DEPARTMENT OF THE AIR FORCE
AIR FORCE BASE CONVERSION AGENCY

SUBJECT: Submittal - Primary Document - Final Supplemental Investigations Report

Final Response to Comments Draft Report for Supplemental Investigations of Areas of Concern Griffiss Air Force Base Submitted November 1997

Comments on Draft SI Report sections by Dean Williams, U.S. Army Corps of Engineers, Kansas City District, Dated November 1997.

**Figure 4.11.4.6-1
 SUPPLEMENTAL INVESTIGATION
 SAMPLE LOCATION MAP
 GROUNDWATER CONTOUR MAP
 BUILDING 133 STORAGE VAULT**

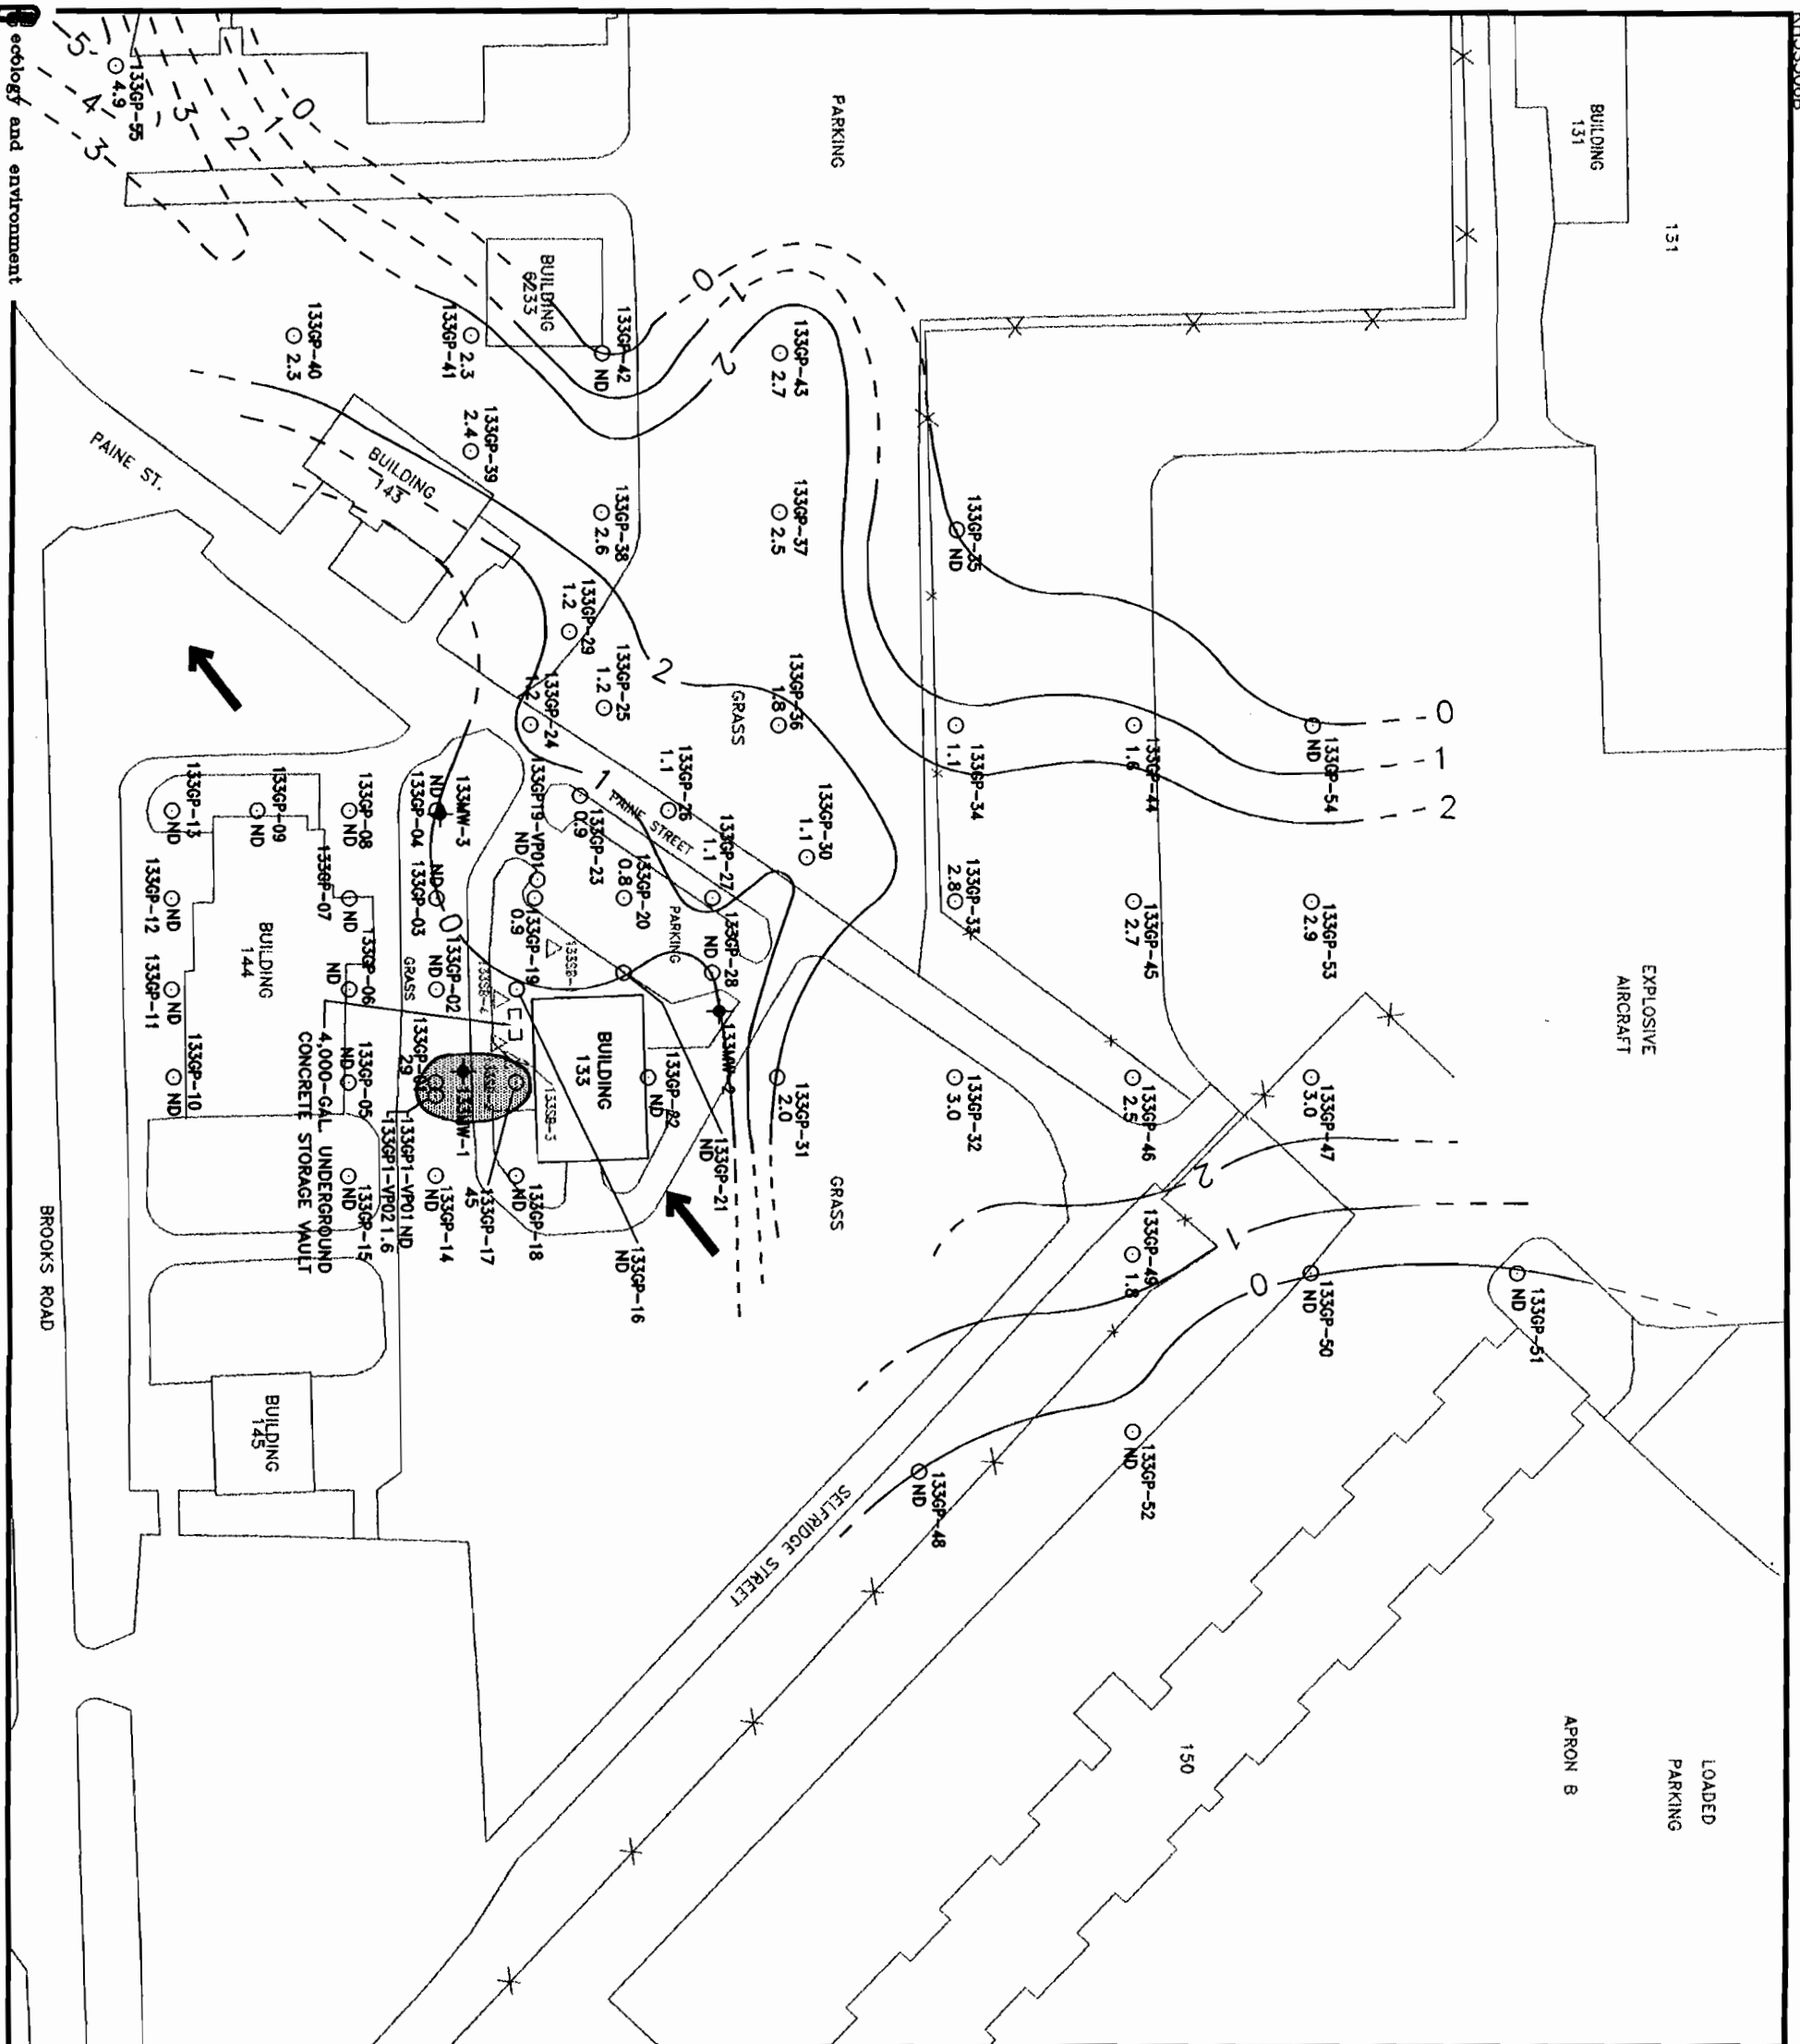
Figure 4.11.4.6-1: Finalized geoprobe locations.

Figure 4.11.4.7-1
SUPPLEMENTAL INVESTIGATION
SAMPLE LOCATION AND
GROUNDWATER CONTOUR MAP
NOSE DOCKS 1 & 2 (BUILDINGS 782/783)

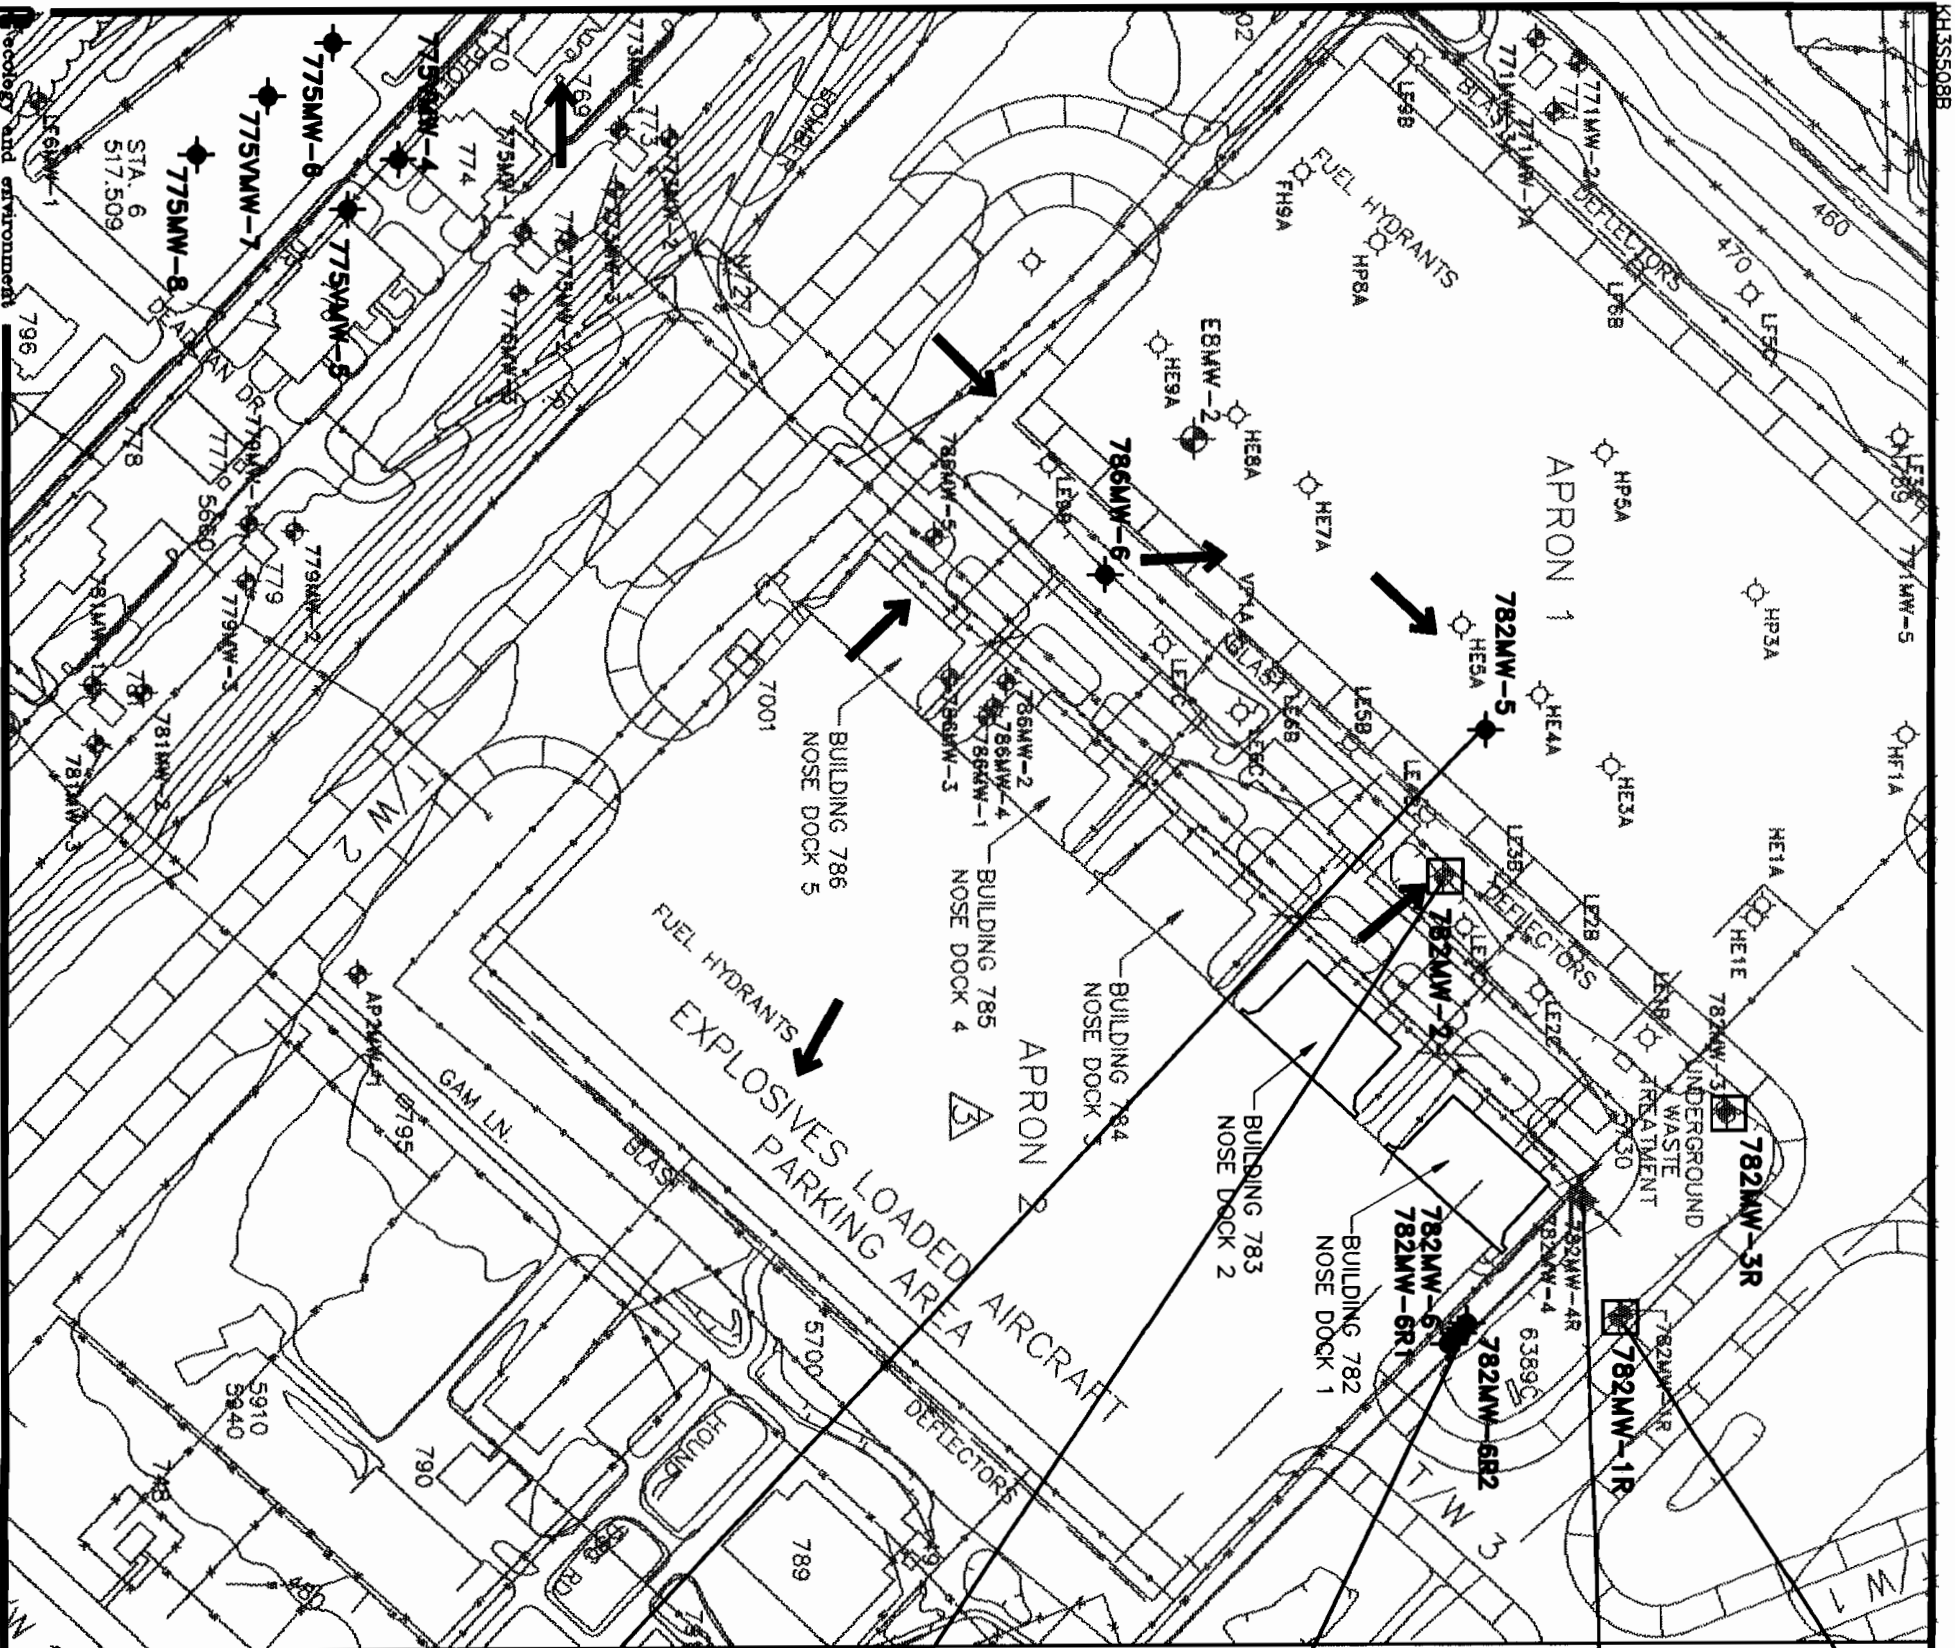
Figure 4.11.4.7-1: Modified contour lines and direction of groundwater flow, and added 782MW-6R2.
